**COUNTY OF ALLEGHENY  
PITTSBURGH, PA.**

**BABCOCK BOULEVARD  
SPILLWAY  
NORTH PARK DAM**  
NORTH PARK, M<sup>C</sup>CANDLESS TOWNSHIP  
**DETAILS OF WING WALLS & WEIR**  
SCALES AS SHOWN  
JUNE 6, 1935  
SHEET 2 OF 4 SHEETS

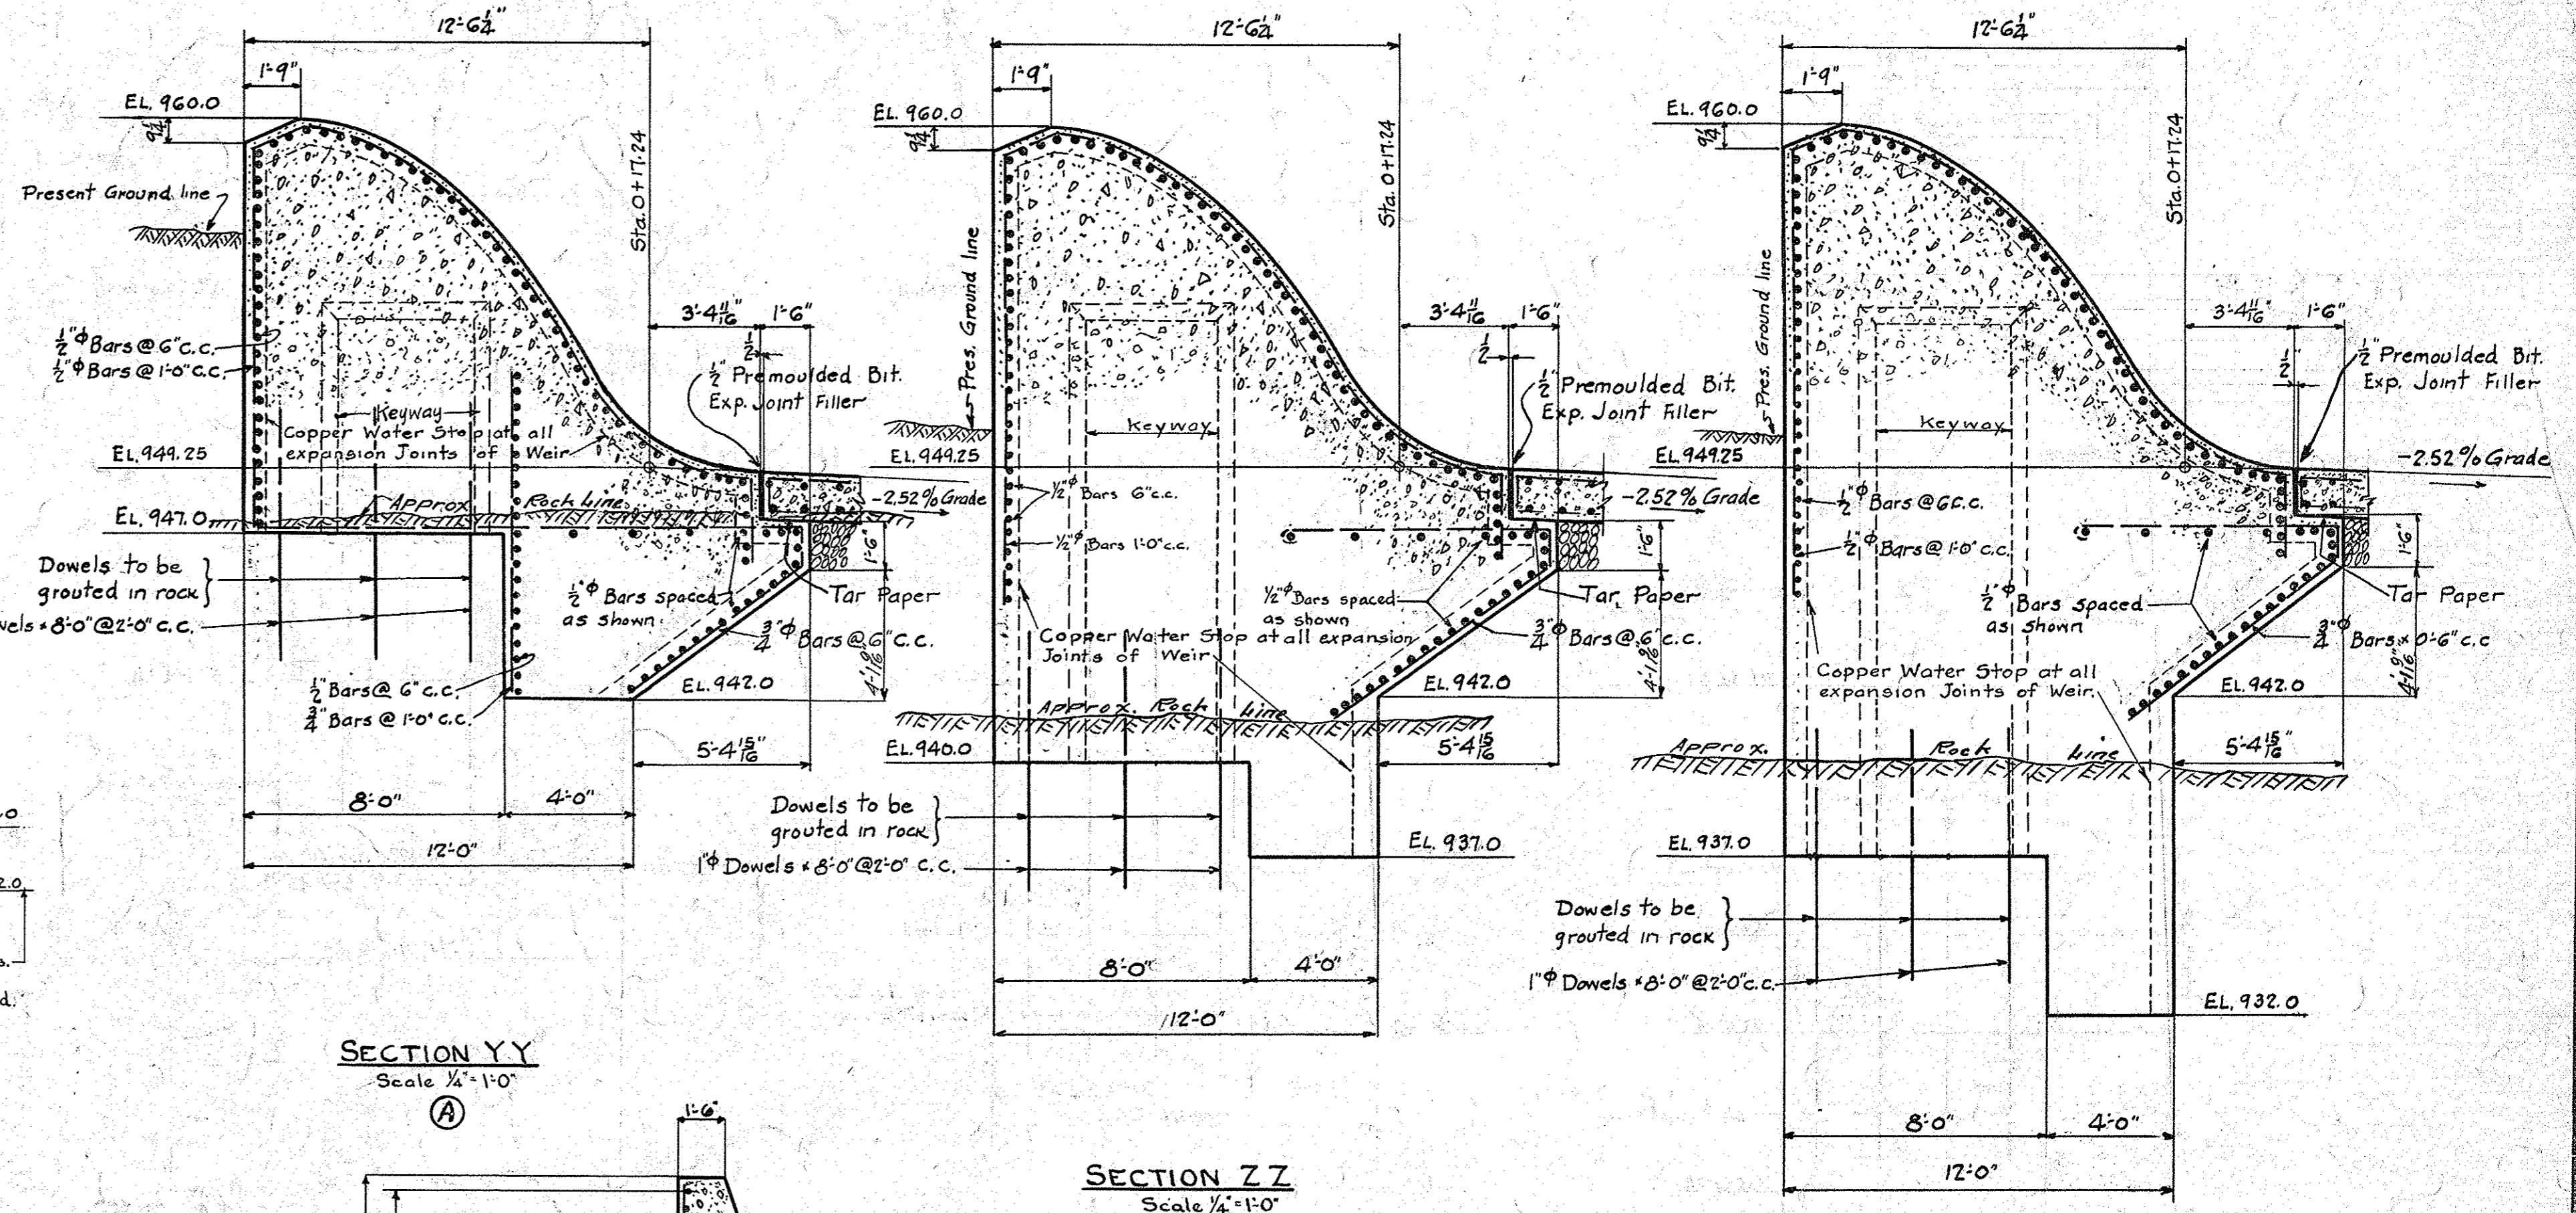
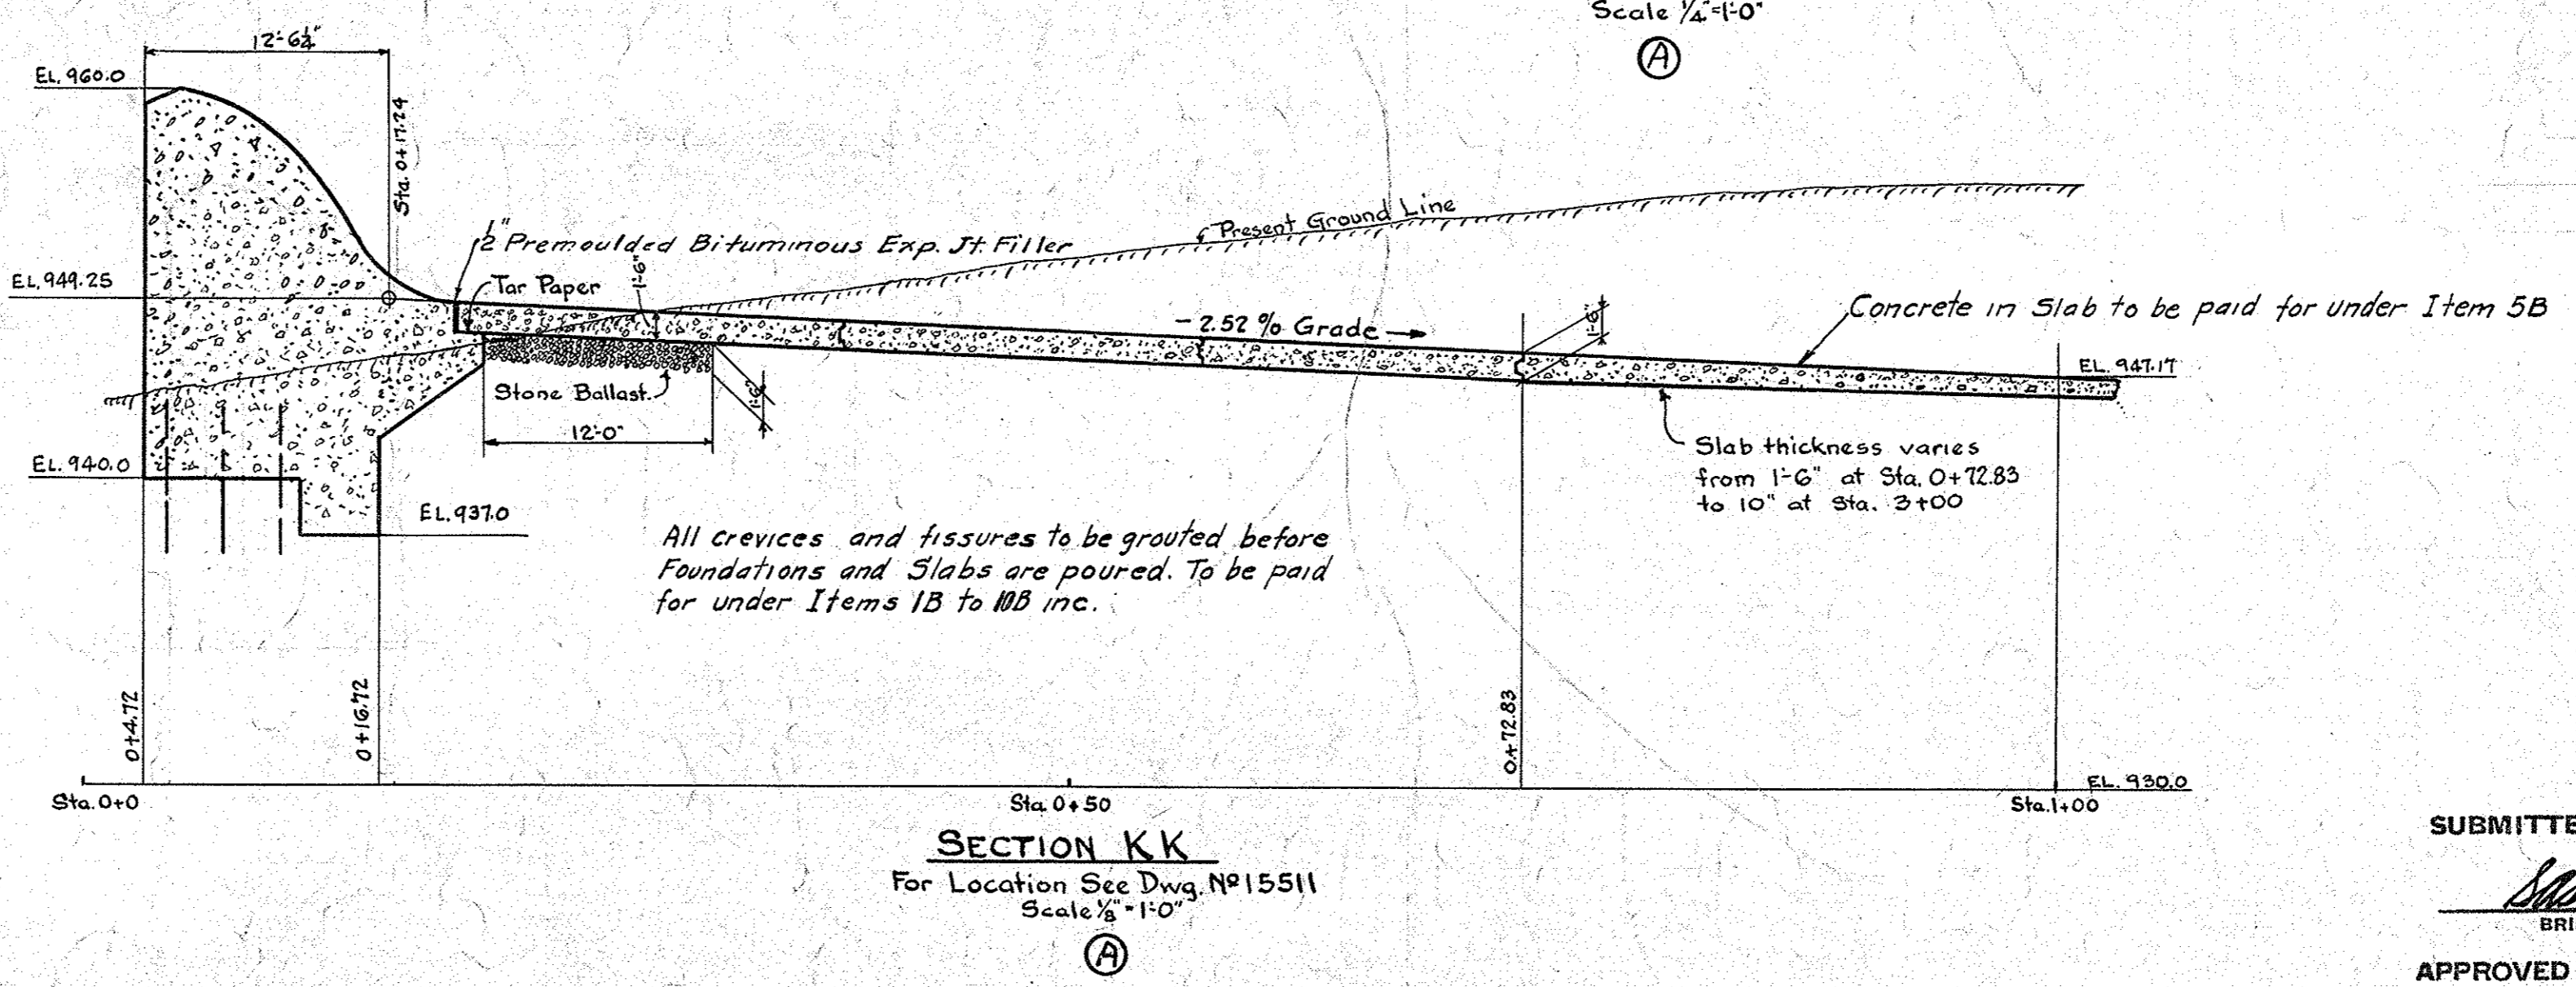
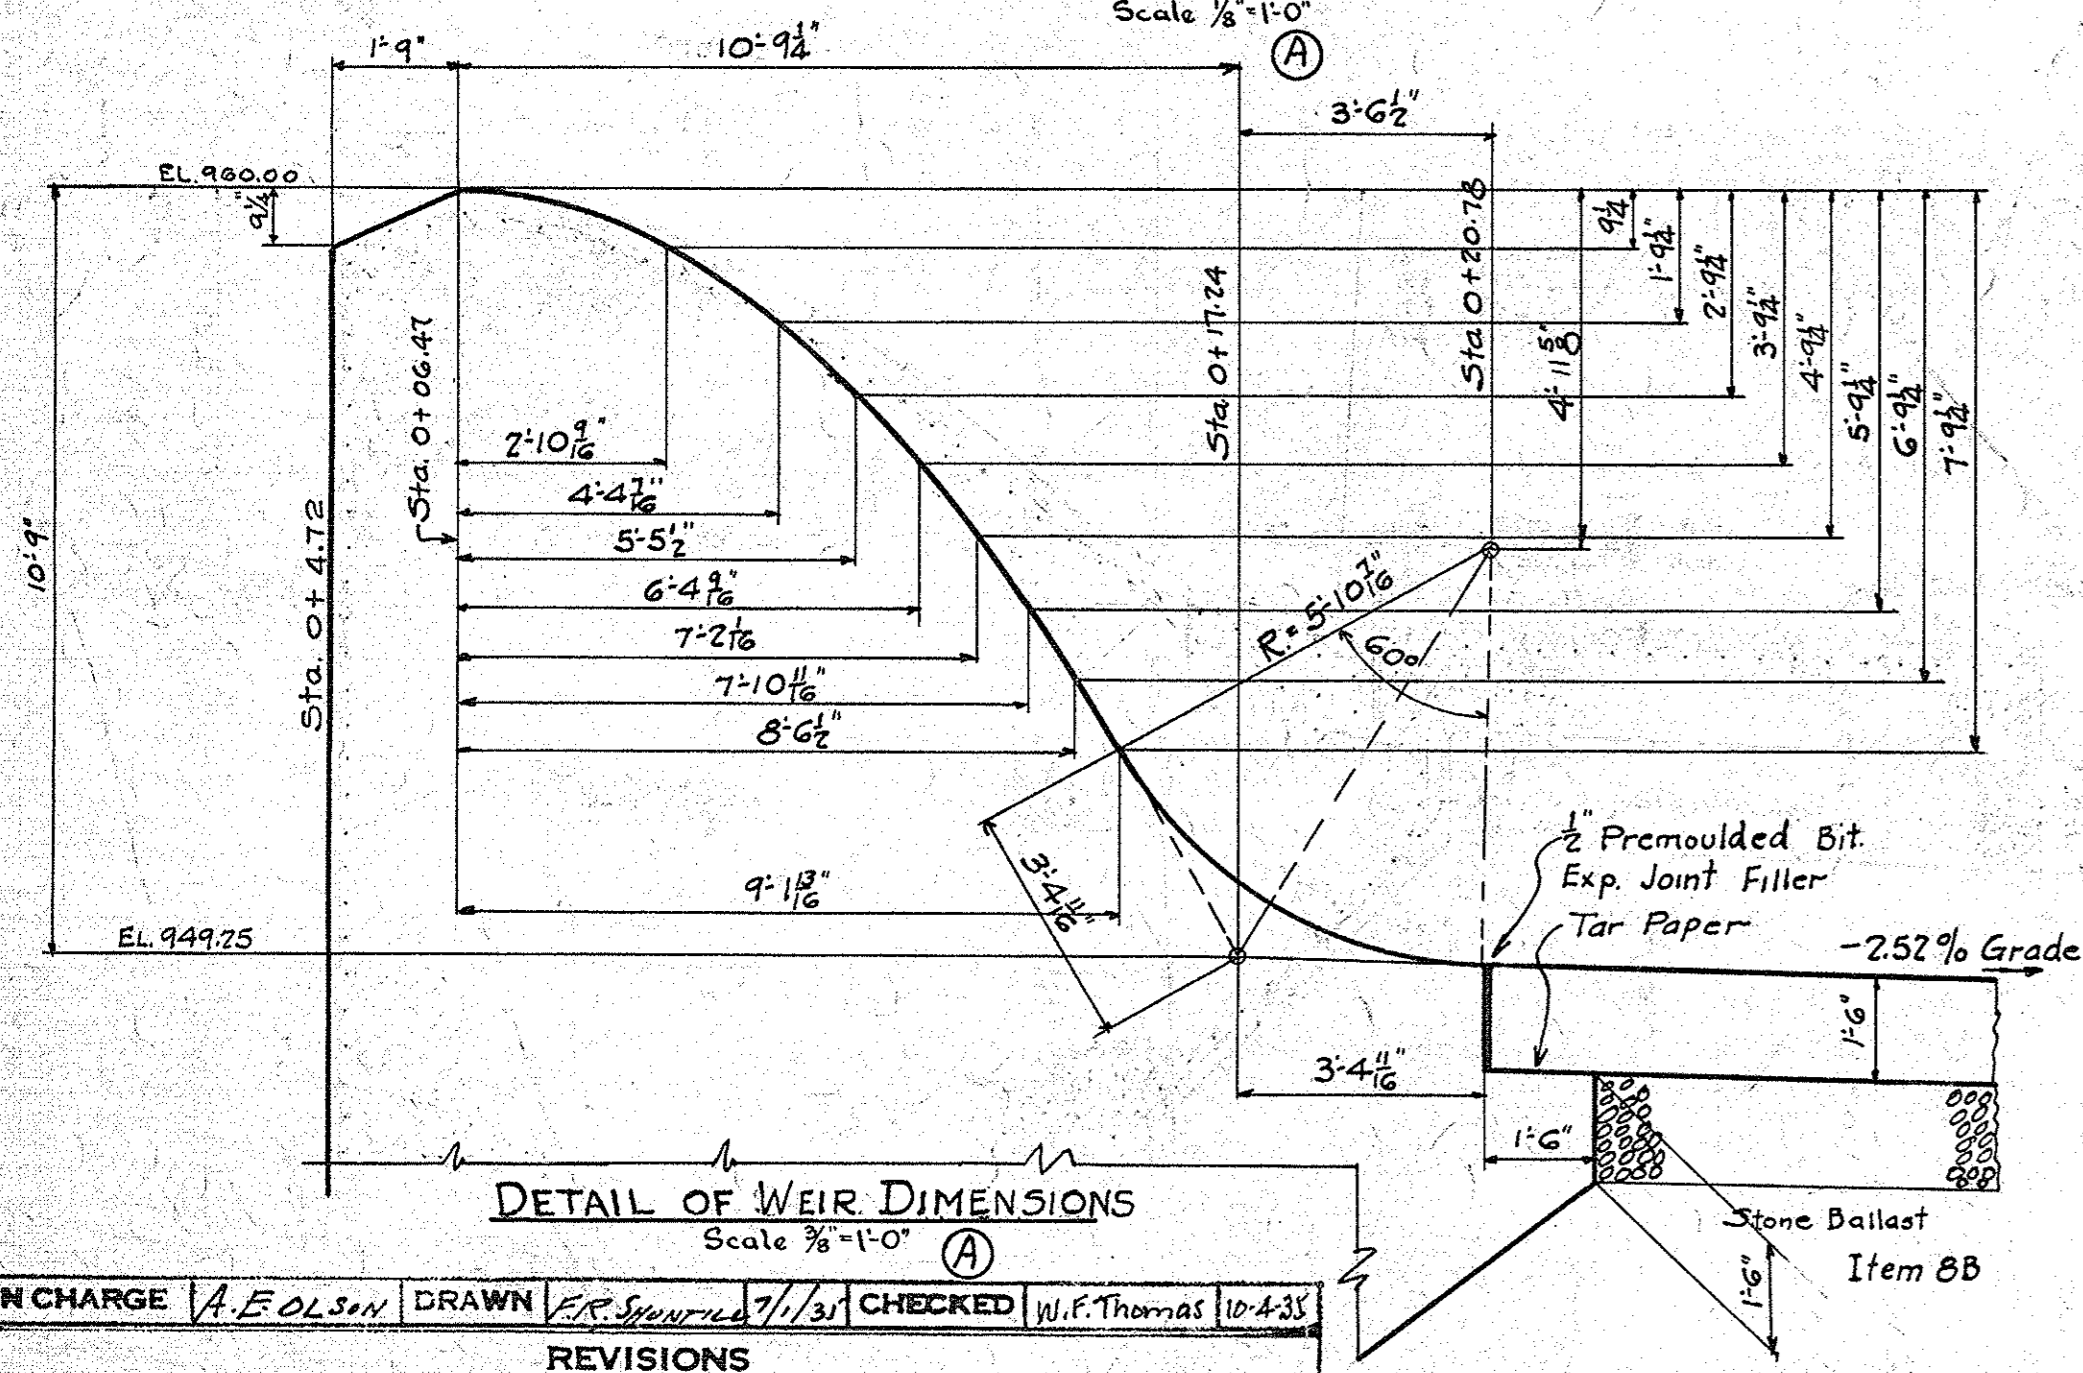
Details, Dimensions and Elevations shown in red indicate structure as built

IN CHARGE	A. E. OLSBY	DRAWN	F. R. SHUBIN	CHECKED	W. F. THOMAS
REVISIONS					
NO.	ORDERED	MADE	DATE	CHECKED	REMARKS
1	S.A. SHUBIN	F.R.S.	9/13/35		CHANGES MADE BY LOWERING SPILLWAY ELEVATION
2	S.A.S.	C.L.N.	3-15-37		REVISIONS TO WEIR STRUCTURES AS BUILT
